REMEDIAL INVESTIGATION WORK PLAN ADDENDUM FOR GROUNDWATER
MONITORING WELL INSTALLATION AT SITE 45 FACILITY 11 NAS CECIL FIELD FL
4/6/2000
TETRA TECH NUS INC

**Remedial Investigation Work Plan Addendum
Groundwater Monitoring Well Installation
Site 45, Facility 11
Naval Air Station Cecil Field
Jacksonville, Florida**

April 6, 2000

PROPOSED MONITORING WELLS
 SITE 45, FACILITY 11
 NAVAL AIR STATION CECIL FIELD
 JACKSONVILLE, FLORIDA

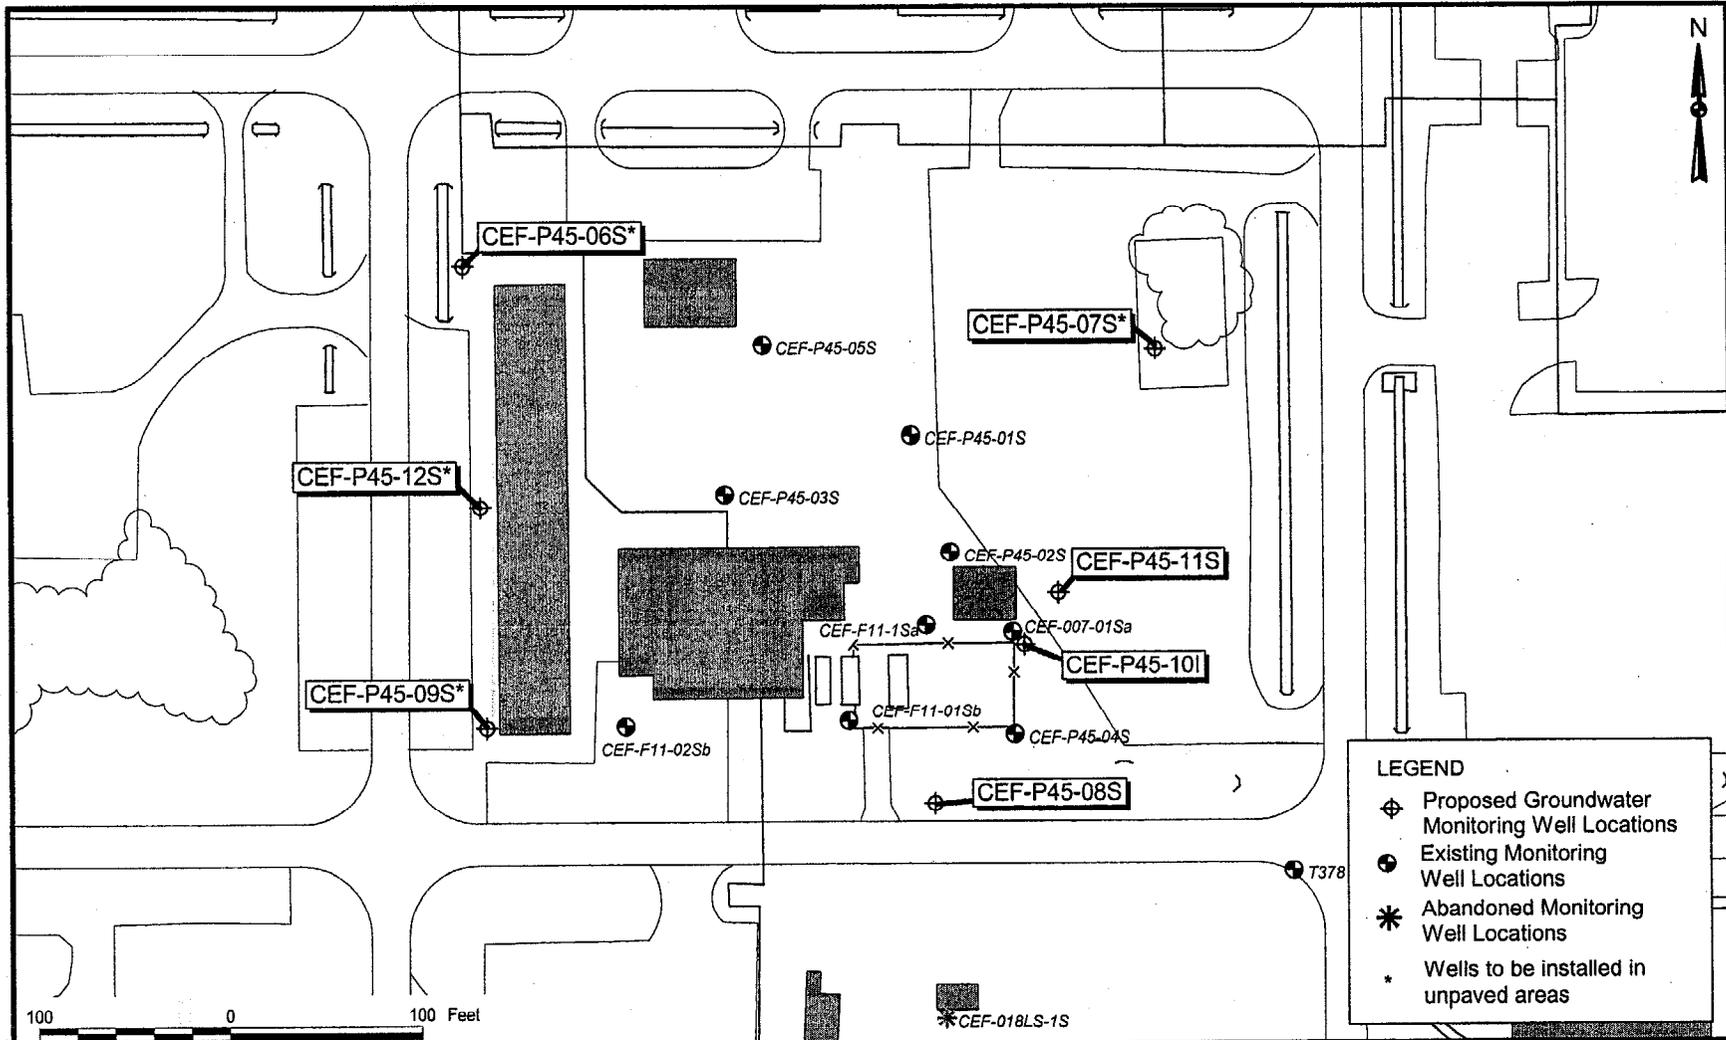
In addition to the well installation and sampling proposed in the Site-Specific Remedial Investigation (RI) Work Plan, installation and sampling of one additional well and resampling of five existing wells is proposed for PSC 45, Facility 11. As identified in Figure A, this additional well, CEF-P45-12S, will be located to the west of Building 12, approximately midway between proposed wells CEF-P45-06S and CEF-P45-09S

Prior to the installation of the new well, utilities must be located or cleared at the proposed location.
